**ADDENDUM NUMBER #1**

PROJECT	BIDS DUE
Ottaway Crossing Bridge and Site Work GFA Project No: 23101	Date: <b>April 1, 2025</b> Time: <b>2:00 PM</b> Location: GTCD Office 1450 Cass Road Traverse City, MI 49685

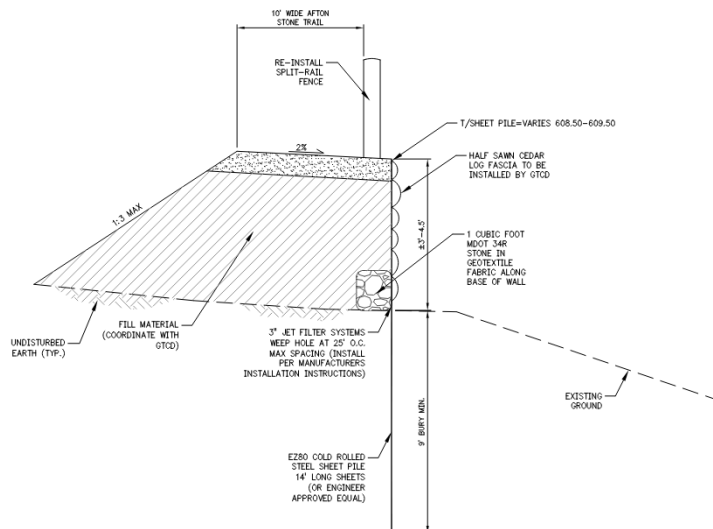
5. Detail 3 on Sheet 8 of the plans shall be stricken in its entirety from the bid documents and replaced with the following:
